Subject: Calvert Cliffs Nuclear Power Plant
Units Nos. 1 & 2; Dockets Nos. 50-317 & 50-318
Response to NUREG-0737 Items II.K.3.2 & II.K.3.17

Response to Request for Additional Information
NUREG 0737 Item II.K.3.2

FIGURE 1

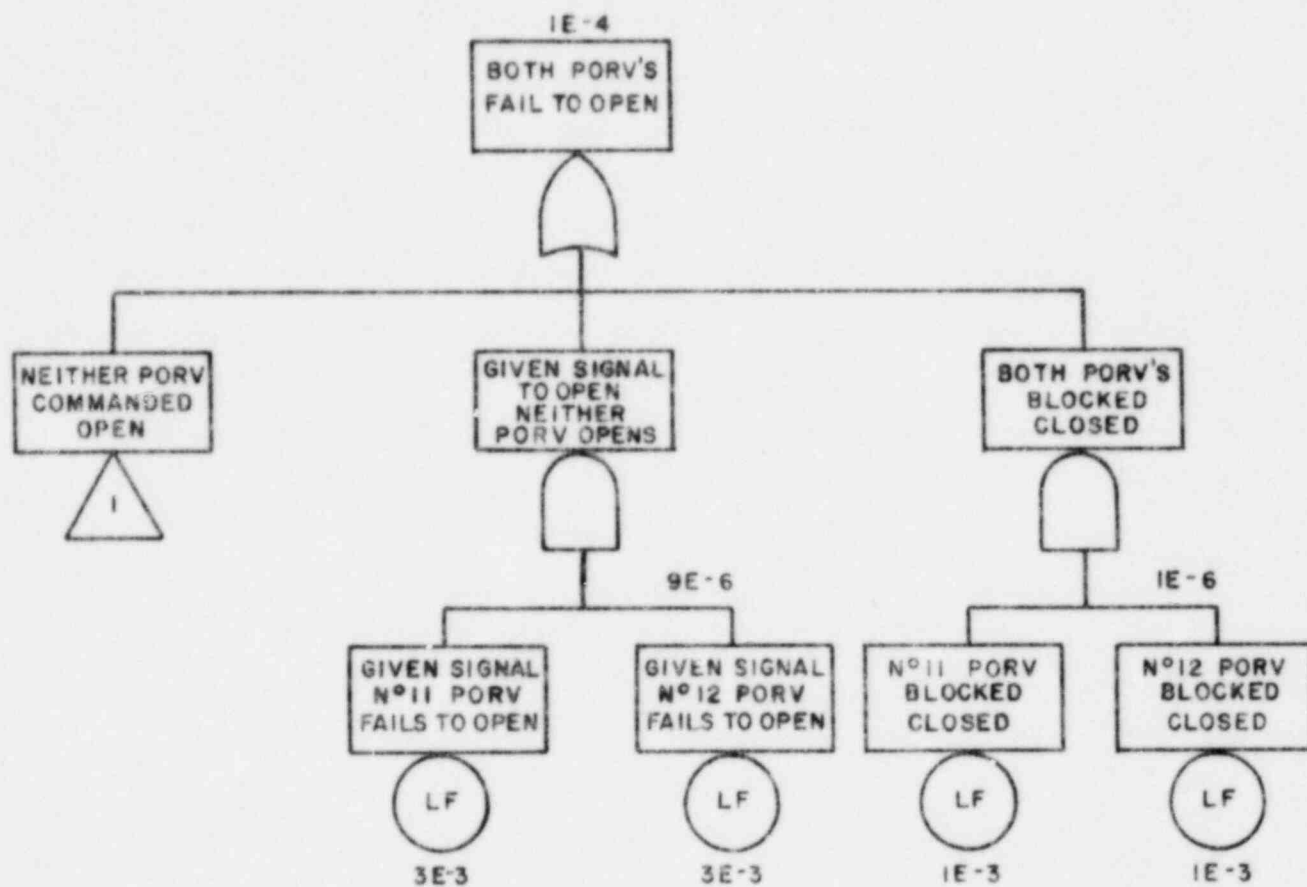
3. Q) Submit an analysis of the probability of a small break LOCA caused by the stuck-open safety valve using the calculated safety valve failure rate.

- A) Attached.

Assumptions:

1. Given RCS pressure increase which does not challenge PORV, it will challenge SRV which is subject to premature operation.
2. Even though reactor trip may occur, if PORV is challenged and fails to open, the SRV will be challenged.
3. If PORV is challenged and operates (opens) successfully, no challenge to the SRV will occur (not true for ATWS events).
4. Multiple openings do not occur (see response to Question 1).
5. Only one SRV will open due to setpoint drift, while both PORV's open on a legitimate demand.

Data:

High RCS Pressure: 1 per year (IREP Table C.3.2 for CE Plants)

Challenge PORV's given that RCS High Pressure occurs: 0.1 (IREP Table C.3.2 for CE Plants)
